PCD File No. VA265

OFFICE / YARD
7620 MOHAWK ROAD
COLORADO SPRINGS, CO

SITE PLAN
20 SCALE

S-2

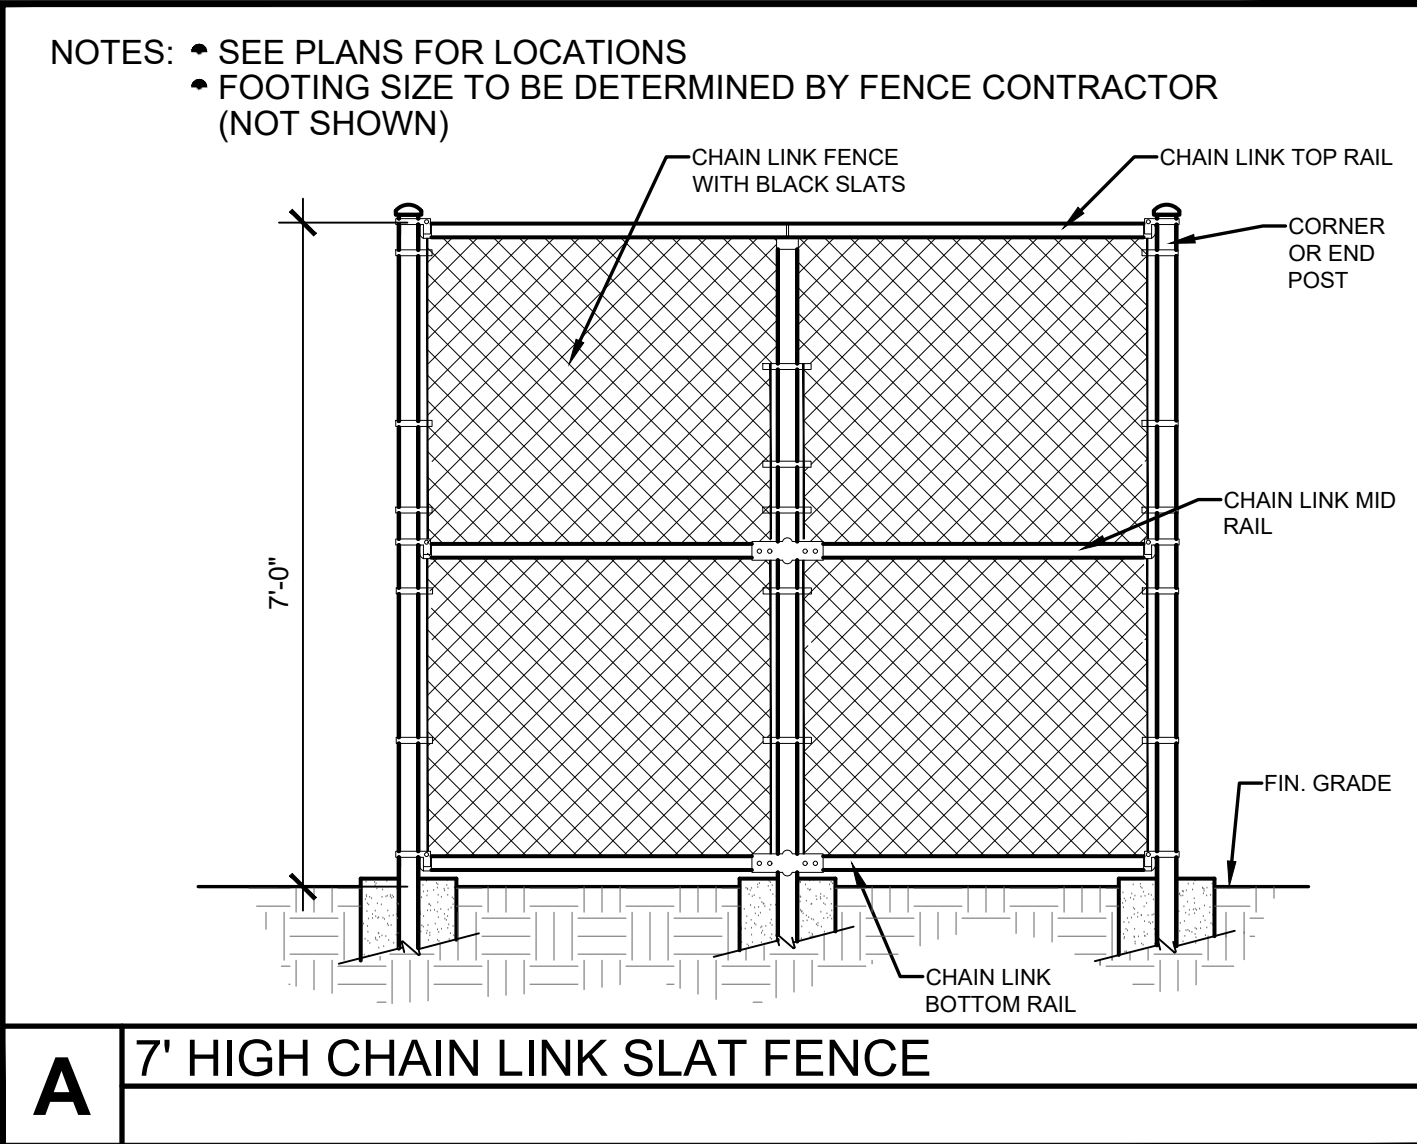
Per ECM 2.4.1.E:
Two-way commercial or industrial parcel access points on Nonresidential Collector and Local Roadways must provide a minimum 25-foot and maximum 40-foot access width.

Revise the width of the two-way commercial access to a minimum of 25 feet.

Per ECM 2.4.1.G:
Commercial, industrial, or multifamily development must install an asphalt or concrete apron for the first 50 feet of any new access connecting to a paved roadway.

Depict 50 feet of paving (asphalt or concrete) for both access points on the plans.

Please add a table that explains the different hatching/colors/road materials etc
